MAESTRO

TECHNICAL

Item 28

Item 29

fig. 29/1

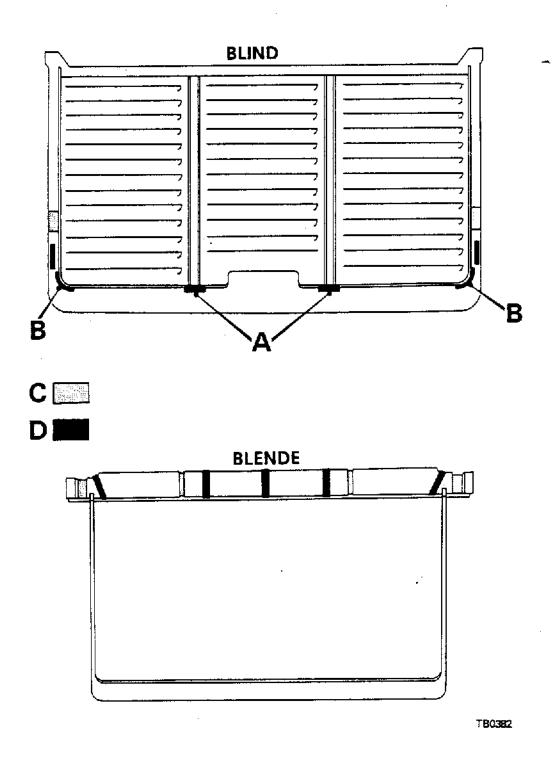
Rattles originating from sun roof blind or "blende"

Reposition or fit new "Velcro" strips as shown:

- A = Replace foam pads with "Velcro" strips of the same length.
- 8 = No change leave strips in original positions.
- C = Remove original strips
- D = New position fit Velcro strips.

Where existing strips are fit for re-use, they can be

secured in their new positions with "superglue". Where new strips are required, rolls of self adhesive "Velcro" strip 10 mm wide are available from Unipart under part number EZM 10004.
